CITY OF DUPONT

Project: Dupont 243 PLNG 2022-031 (Type III Site Plan Review) and PLNG 2022-032 (SEPA)
Subject: Review Comments and Request for Additional Information

**Re: Updated DuPont 243 Noise Study Peer Review
Permit Nos. PLNG2022-031 and PLNG2022-031-032
DuPont, Washington
Landau Project No. 1260016.010**

SUBJECT: REVIEW COMMENTS, DUPONT 243 (LOT Y)
CITY OF DUPONT, PIERCE COUNTY, WASHINGTON
G&O #20303.00

Job Number
18666
Sheet
C7 of 13

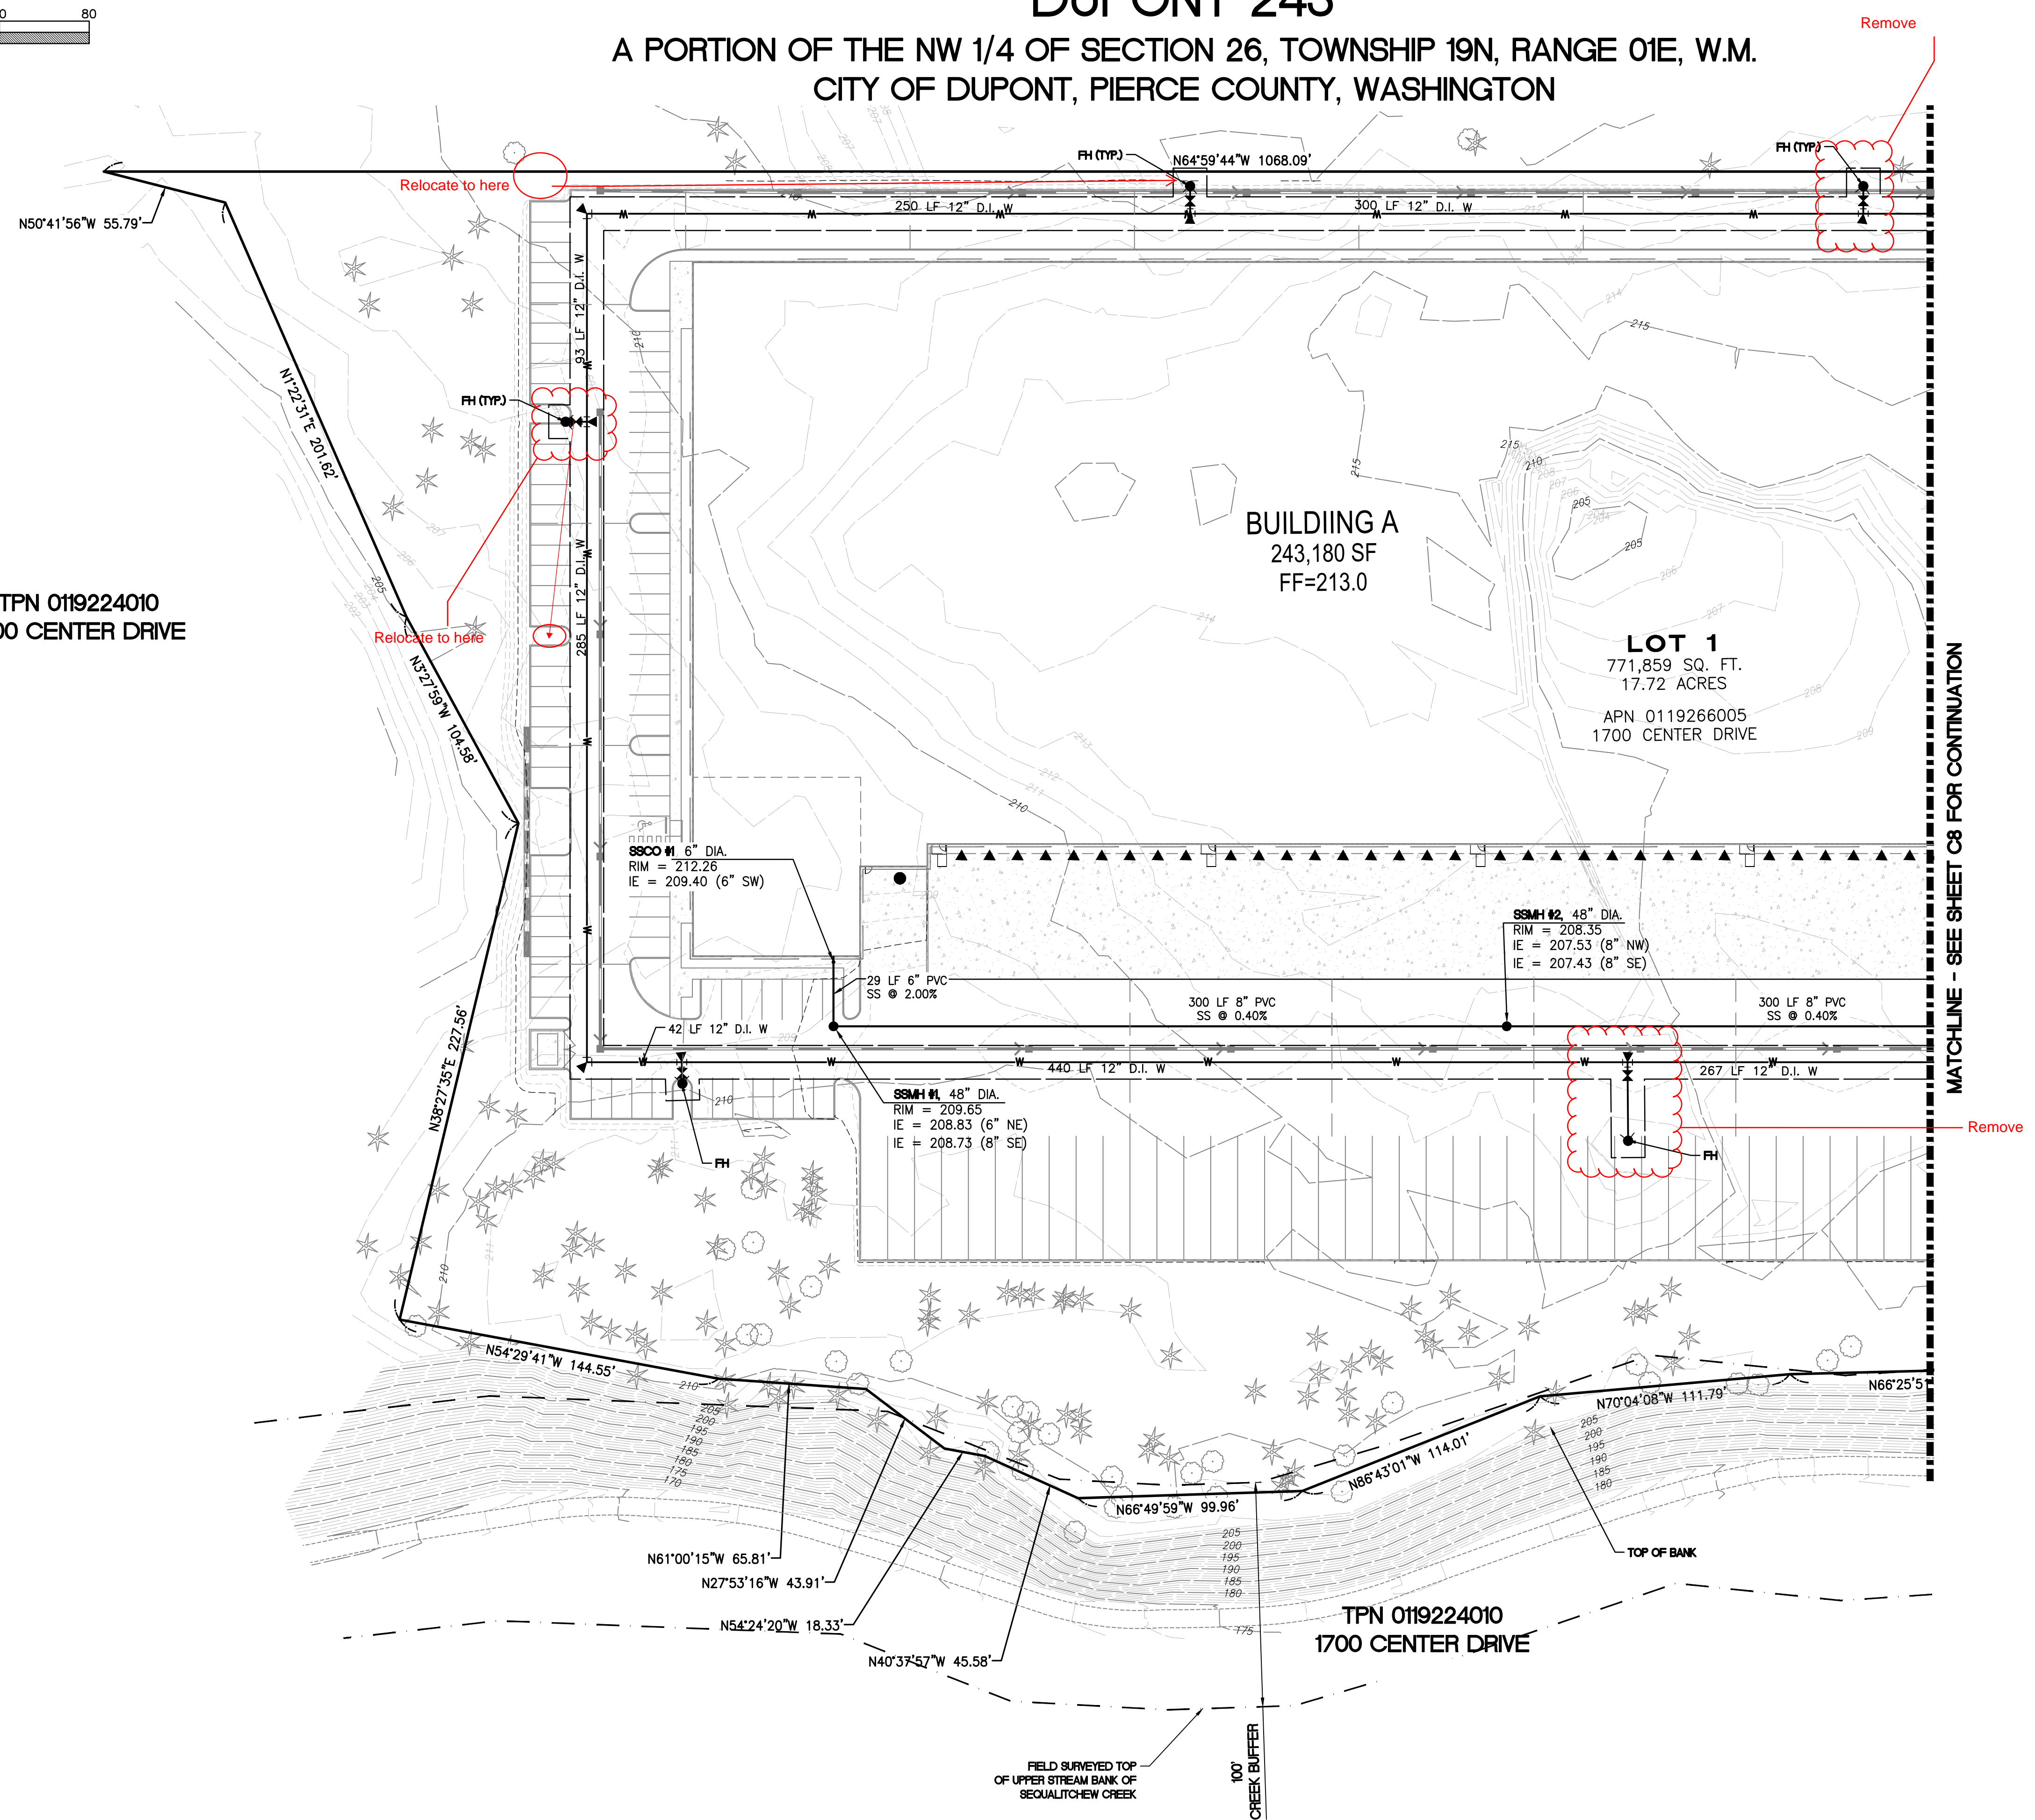
Enclosures: Noise Study Peer Review letter prepared by Landau dated August 25, 2023
Fire Marshal Plan Comments on Sheet C7 and C8
Gray & Osborne Comment Letter dated August 20, 2023
G. Reinart Traffic Review Comment Letter dated August 15, 2023
